## PRODUCT ALERT

# RGB561 220 MHz and 250 MHz, Blanking Skew

Fig 1a. Normal frame buffer, normal timing.

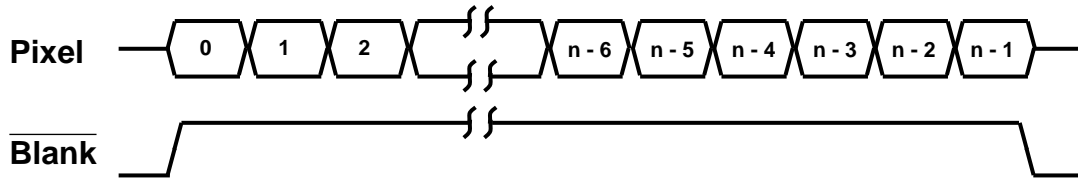
At high speeds the internal synchronization of the pixel data and the blank timing can become offset by one pixel clock, such that  $\overline{\text{CBLANKIN}}$  is “skewed to the right” by one pixel time relative to the pixel data. This causes two visible effects:

1. The first (left-most) pixel of each scan line is discarded.
2. An extra (right-most) pixel is displayed at the end of each scan line.

Each LOAD\_CLK clocks in a number of pixels which are multiplexed down at pixel clock speeds. The extra pixel that is displayed at the end of the scan line is left over from the previous LOAD\_CLK. If, for example, 4:1 multiplexing is used, whatever pixel is normally fourth from the end of the scan line is the pixel that will be incorrectly duplicated at the end of the scan line.

See Figures 1a and 1b for illustrations of normal pixel display and pixel display with the timing problem.

Fig 1d. Frame buffer with black pixels, with bad timing. The left-most black pixel is discarded; an extra black pixel displays at the right.

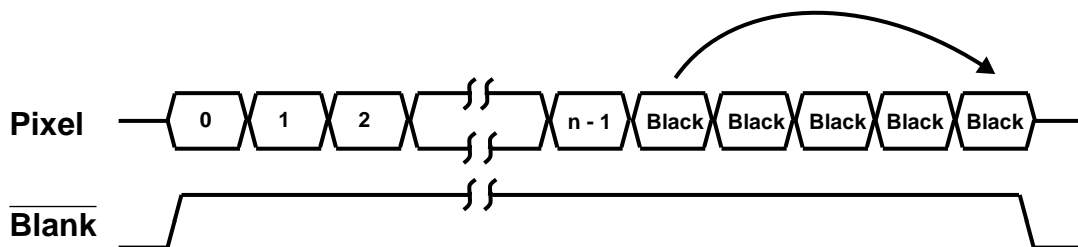
See Figures 1c and 1d for illustrations of the work-around applied, for normal pixel display and pixel display with the timing problem.

1. Start each line with one or more black pixels.
2. Adjust the timing of  $\overline{\text{CBLANKIN}}$  such that the black pixel is normally displayed. If the timing problem exists the black pixel will be discarded. If the timing problem does not exist the pixel will be displayed but will not be visible because it is black.
3. End each line with a string of black pixels. The number of black pixels to use is the number of pixels loaded with each LOAD\_CLK. E.g., in 4:1 mode use four black pixels.
4. Adjust the timing of  $\overline{\text{CBLANKIN}}$  such that the black pixels are normally displayed. If the timing problem

does not exist the black pixels will be displayed but will not be visible because they are black. If the timing problem exists an additional black pixel will be displayed.
